**CLARIFICATION #III
FOR**

**PROCUREMENT OF PLANT DESIGN, SUPPLY, DELIVERY, INSTALLATION, TESTING AND COMMISSIONING OF LOT 1: 400 kV
RATMATE SUBSTATION AND WORKS AT LAPSIPHEDI AND NEW HETAUDA SUBSTATIONS, LOT 2: 400 kV NEW BUTWAL
SUBSTATION, LOT 3: 400 kV NEW DAMAULI SUBSTATION
Ref No: **MCA-N/ETP/CB/004**
Issued on: 17 July 2023**

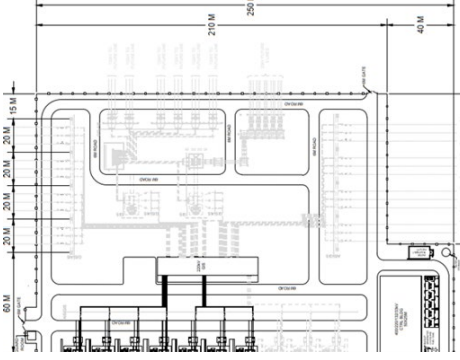
100.	<p>Price Schedule-Ratmate 2.21 Works at New-Hetauda 2.21.1 Approach cable and hardware for termination of OPGW including joint box of Ratmate – Hetauda D/C Lines at New Hetauda Substation End including necessary AC,DC and Interfacing cable for tele protection application. Addition to the above Telecommunication works should include connection, extension and configuration of the local and network remote fiber optic equipment and all works required for the connection, extension and</p>	<p>Since Hetauda is existing substation, please clarify the scope.</p> <p>1) OPGW cable shall be available at Substation Gantry. Bidder has to consider FO Cable and Accessories to connect the OPGW Cable to existing Communication Panel. 2) Please Confirm the additional Spare slot is available in communication panel already installed in NEA Hetauda Substation to connect the FO cable. 3) There is no Phone/ EPBAX System is required at Hetauda Substation, as it is already available with NEA. 4) Necessary Shutdown shall be provided by MCA to interconnect the FO cable for final commissioning.</p>	<p>1 and 2) Abide to the requirements “network remote fiber optic equipment and all works required for the connection, extension and configuration” 3) PABX will be located in Ratmate. Contractor will provide all material and services for interfacing with the existing network 4) To be coordinated by the Engineer</p>

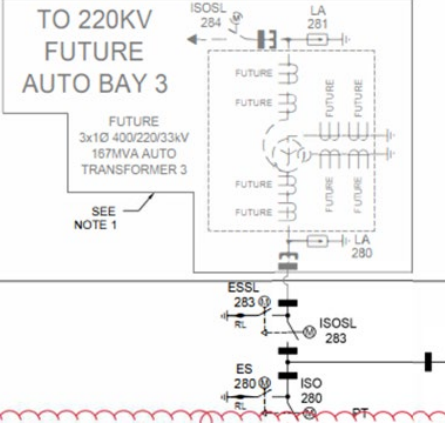
102.	New Butwal Shutdown 220kV AIS Bays	As per Scope of work 2 nos. 220kV AIS bays to be supplied and installed. During construction period many tools and tackles, machinery will be moving for civil / installation works.	MCA-Nepal will assist the Contractor to conduct the necessary coordination. The Contractor needs to ensure that the safety

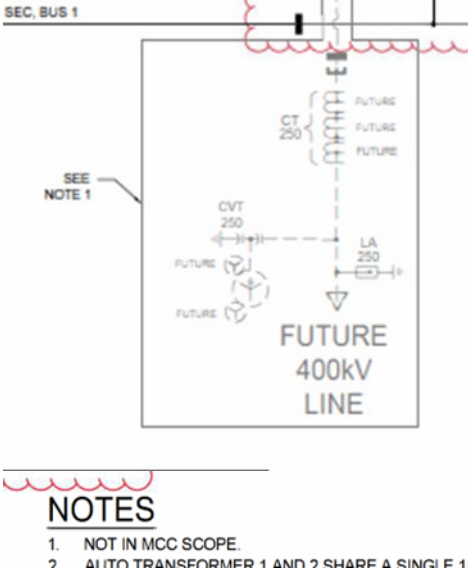
105.	For All Lots-Base and Option <i>Other necessary works as per Employer's Requirement and Conditions of Contract, if any, not included above (specify).</i>	Majority of items is Quantified in the Price Schedule except Lot items. BASE and OPTION Prices to be quoted as per Price Schedule.	a) Bidders are requested to go through the Employer's requirement to understand the scope of work.

SN	Reference to the Bidding Document	Questions from Bidders	Response of Millennium Challenge Account Nepal (MCA-Nepal)
		<p>For many Line items "Other necessary works as per Employer's Requirement and Conditions of Contract, if any, not included above (specify)" is mentioned at multiple locations in each Price Schedule of BASE and OPTION.</p> <p>Bidder request to confirm following:</p> <p>a) Since it is turnkey contract Bidder understand necessary works limited to Substation only is in bidder scope. Please confirm.</p> <p>b) Please clarify the expectation & Scope of MCA Nepal from above mentioned highlighted line items to estimate and quote right price.</p> <p>c) In Schedule 4.4.2, please confirm item no. 4.4.2.5 without Unit and quantity is not applicable to quote. Since scope is also not clear.</p> <p>d) Above line items is "Not Applicable", "Included" for respective item of each Schedule of BASE & OPTION. Some bidder may quote "Included" and Some bidder may not quote for the same item.</p> <p>This may lead to unclear pricing by each bidder. MCA will also not able to evaluate the price during price evaluation. Please clarify how bidder shall proceed for filling the line items.</p>	<p>b) Bidders are required to go through the Employer's requirement and include price for everything that is required to design and construct the required scope of work as per the Employer's requirement and conditions of Contract. The Employer's expectation is that the Bidder should include the price of the complete scope of work including the cost required to carry out the scope of work. The Bidders are also requested to specify those items, however, even if those items are not specified or listed but required as per Employer's requirement must be included under Bid Price. MCA-Nepal will review the same and will issue an addendum to the bidding document subject to the approval of the authority.</p> <p>c) Same as above.</p>
